Second Five-Year Review Report
for
Coakley Landfill Superfund Site
North Hampton and Greenland
Rockingham County, New Hampshire

September 21, 2006

Summary of Historical Groundwater Analytical Results
 FPC 6B Bedrock (Arsenic)

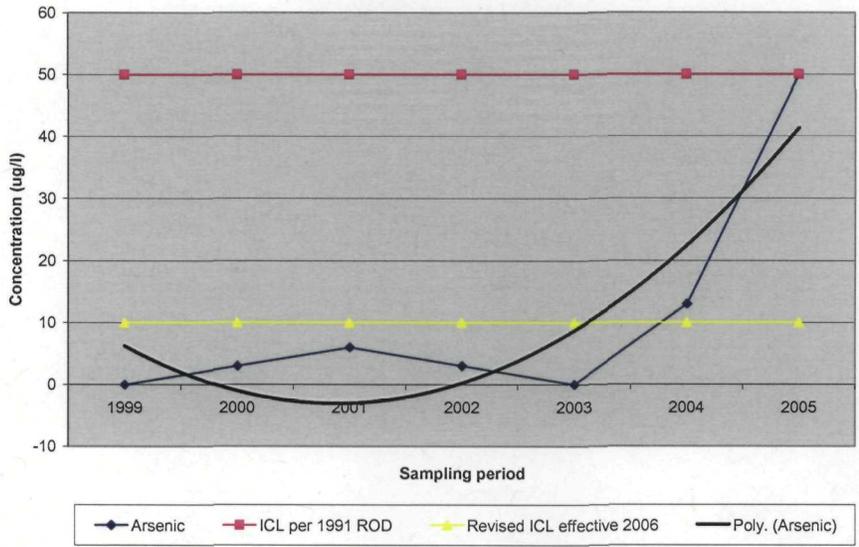
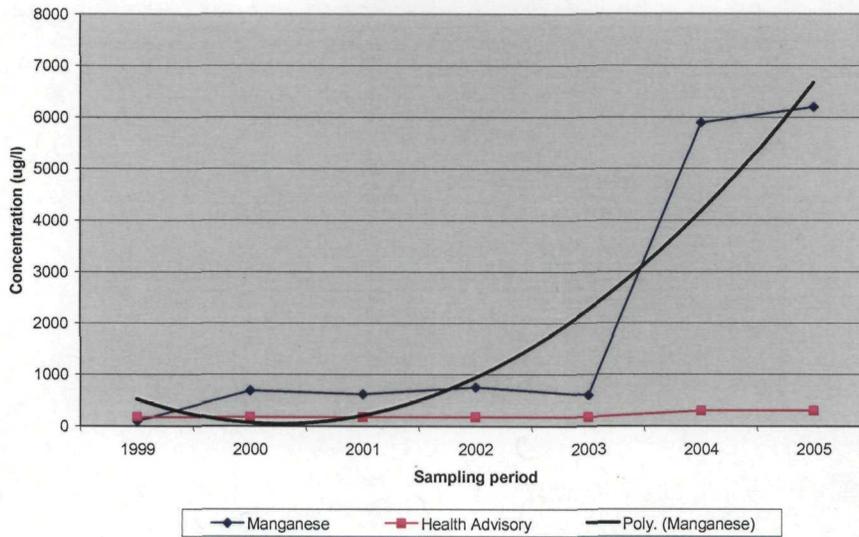
Monitoring well FPC-6B shows high levels of manganese (6,200 ug/l) and arsenic (50 ug/l). This well is on the edge of the proposed GMZ. A determination needs to be made whether elevated levels are coming from or caused by the landfill or from a source other than the NPL site. CLG will need to collect and analyze more data to answer the question and present its findings to USEPA and NHDES, so that a decision can be made whether the scope of the groundwater remedy needs to be modified. Depending on the findings, it may be necessary to either 1) expand the proposed GMZ in order to locate a clean edge or 2) reduce the proposed GMZ if it is determined that the well is influenced by non-NPL site sources of contamination. Several other monitoring wells near the edge of the proposed GMZ will require a similar evaluation as noted for well FPC-6B.
